Air Pollution Control District  
San Luis Obispo County

September 4, 2020

SUBJECT: California Department of Parks and Recreation's August 1, 2020 Oceano Dunes SVRA  
Draft 2020 Annual Report and Work Plan in Response to Stipulated Order of Abatement  
Number 17-01

San Luis Obispo Air Pollution Control District Comments on August 1, 2020 Draft ARWP  
September 4, 2020

**10 Baseline Days, Modeled vs Observed PM 10**

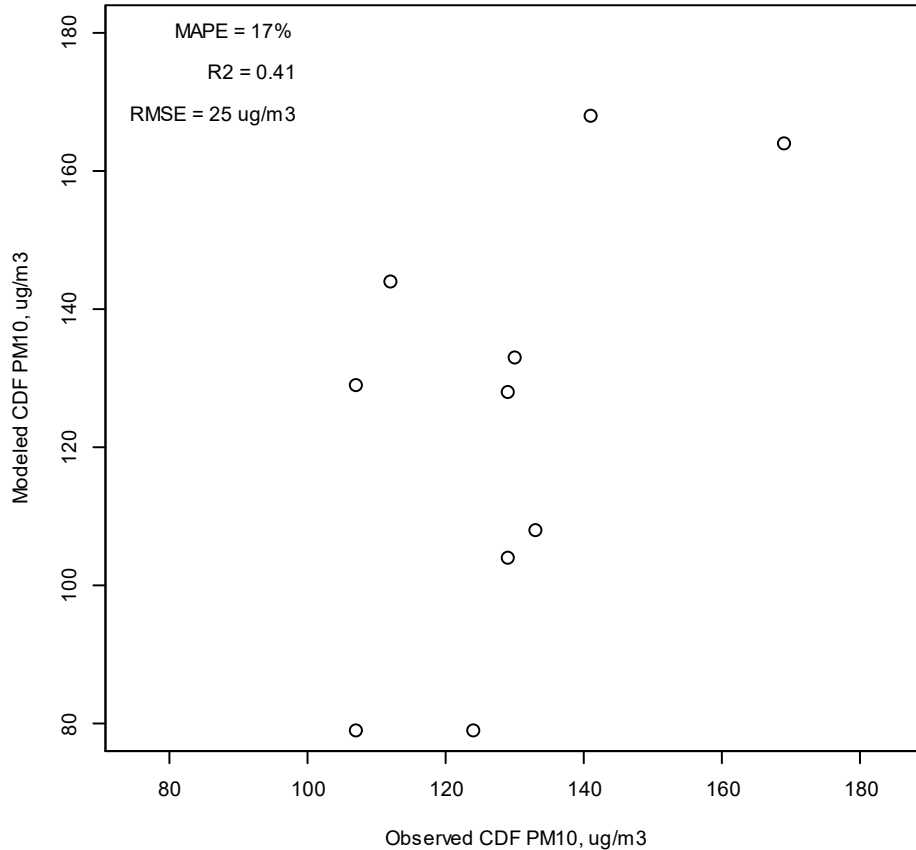
The District supports the using the 10 “baseline days” for evaluating progress toward mitigating ODSVRA dust impacts; however, we do not think it is sound to evaluate the model itself using just these 10 days. As explained below, it would be better to evaluate the model’s performance against the entire dataset or at least a subset of days spanning the full range of observed daily averages.

In the figure below, the CDF data from Table 2-4 in ARWP is presented as a scatter plot rather than a bar graph as in Figure 2-9. Viewed this way, the correlation between modeled and observed  $PM_{10}$  for these 10 days at CDF is not very impressive, and the  $R^2$  for these data is only 0.41. For these 10 points, the mean absolute percent error (MAPE) is 17% and the root mean square error (RMSE) is  $26 \mu\text{g}/\text{m}^3$ ;<sup>10</sup> however, a “naïve” or “intercept-only” model which does not have any meteorological or emissions inputs and always predicts the observed mean ( $128 \mu\text{g}/\text{m}^3$ ), performs even better, with a MAPE of 9.7% and RMSE of  $17 \mu\text{g}/\text{m}^3$ . The results for Mesa2 are even worse: using the DRI predicted concentrations,  $R^2 = 0.07$ , MAPE = 24%, and RMSE =  $25 \mu\text{g}/\text{m}^3$ , while for a naïve model which always predicts the observed mean ( $96.4 \mu\text{g}/\text{m}^3$ ) MAPE = 17% and RMSE =  $20 \mu\text{g}/\text{m}^3$ .

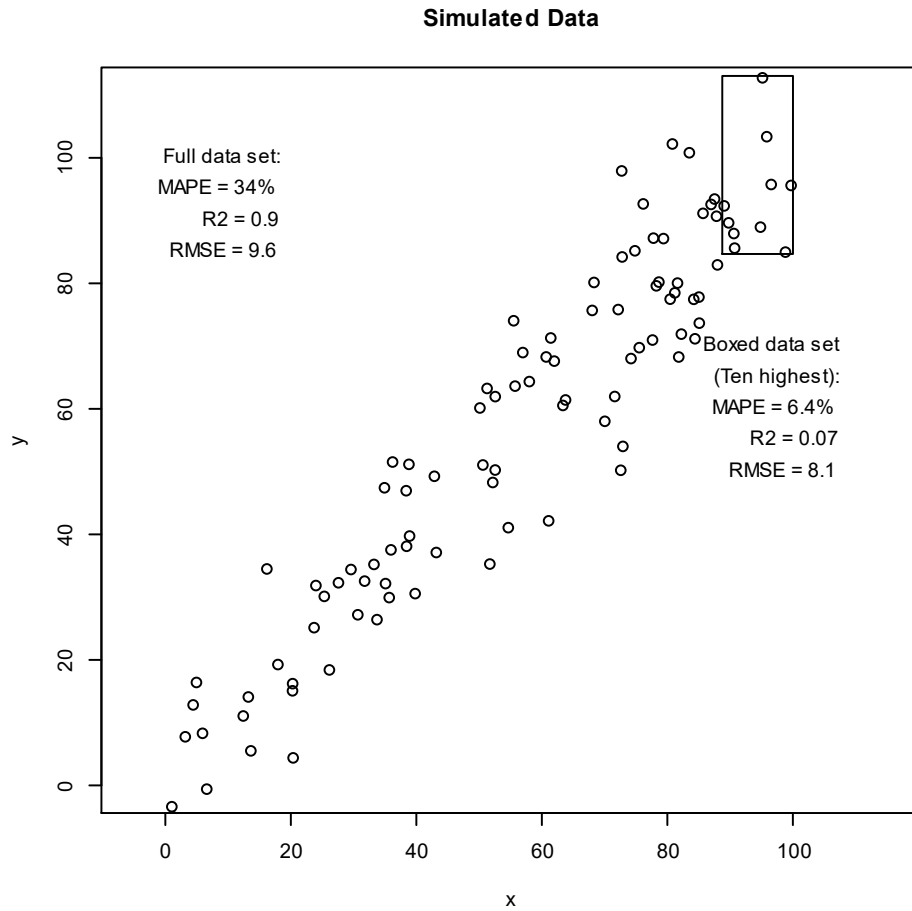
Thus, it would appear that the entire model could be dispensed with in favor of always predicting the mean. This, however, is an artifact of only considering a limited range of the dataset, in this case the 10 highest days. To be clear, the District does not believe that a model with no meteorological or emissions inputs performs better than the DRI model. As shown in the simulated data below,<sup>11</sup> even a strong correlation can appear poor when evaluated over a narrow slice of the data. These 100 points are strongly correlated, with  $R^2 = 0.90$  ( $r = 0.95$ ,  $p$ -value  $< 2.2 \times 10^{-16}$ ); however, considering only the 10 points with the highest  $x$  values, the  $R^2$  is only 0.07 ( $r = 0.27$ ,  $p$ -value = 0.46). If the  $y$  values represent modeled values of  $x$ , then the MAPE and RMSE for the full dataset are 34% and 9.6, respectively. The “model” would clearly outperform a naïve model that always predicted the mean of  $x$ , the MAPE and RMSE of which being, 46% and 28, respectively. On the other hand, considering only the 10 highest points, the naïve model has the better RMSE (3.6 versus 8.1), while they are about the same in terms of MAPE (7.0% versus 6.4%).

<sup>11</sup> The  $x$  values were drawn from a uniform distribution from 0 to 100, and each  $y$  value was generated by adding a draw from normal distribution with mean = 0 and standard deviation = 10 to its corresponding  $x$  value.

For these reasons, the analysis presented in this section of the ARWP does not actually verify the model performance. The District also questions the need for any additional verification, as the model has already been endorsed by CARB and the SAG and published in a peer-reviewed academic journal;<sup>12</sup> however, if additional verification is desired, the District recommends using the entire dataset or at least a subset of days spanning the full range of observed daily PM<sub>10</sub> averages. This applies to both sections 2.3.3.1 and 2.3.3.2, which evaluate model performance against the regulatory sites (CDF and Mesa2) and the temporary E-BAM sites, respectively.
